## SERVICE BULLETIN

SB97.11

**Machines/Models:AB46  
Diesel 2 wd**

**PURPOSE:** Install exhaust support bracket.

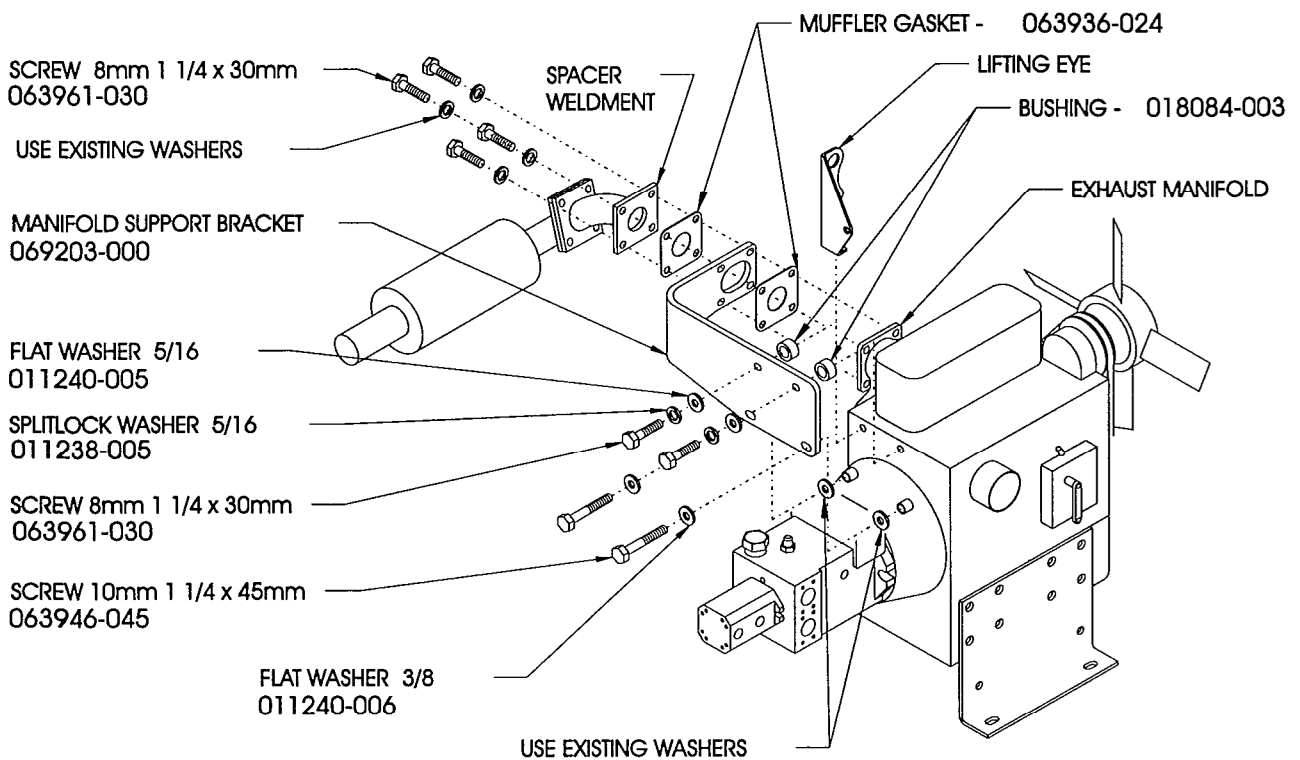
**PROCEDURE:** Read all instructions thoroughly and refer to Figure 1 before starting.

1. Remove the four screws and washers attaching the spacer weldment to the exhaust manifold. (Discard 4 screws and retain washers)
2. Remove lifting eye bolt and lifting eye. (Retain for future use)

3. Remove top 2 bellhousing screws. (Discard screws and retain washers)
4. Place manifold support bracket (069203-000) in position with exhaust manifold and place one gasket (063936-024) on each side of manifold support bracket. Install 4 screws (063961-030) and existing washers through the spacer weldment and manifold support bracket, thread screws into exhaust manifold. Do not tighten attaching screws.

5. Install 2 screws (063946-045) and 2 washers (011240-006) through the manifold support bracket lower holes. Install the 2 existing washers between the manifold support bracket and the upper bellhousing mounting holes. (See Illustration for the position of washers) Do not tighten attaching screws.

6. Position 2 bushings (018084-003) between the manifold support bracket and engine cylinder head. Install 2 screws (063961-030) and 2 washers (011238-005) through manifold support bracket and bushings; thread screws into engine cylinder head. (See illustration for position of screws, washers and bushings) Do not tighten attaching screws.

7. Torque the 4 screws (063961-030) that attach the spacer weldment to the exhaust manifold to 125 in/lbs.
8. Torque remaining manifold support bracket screws to 125 in/lbs.
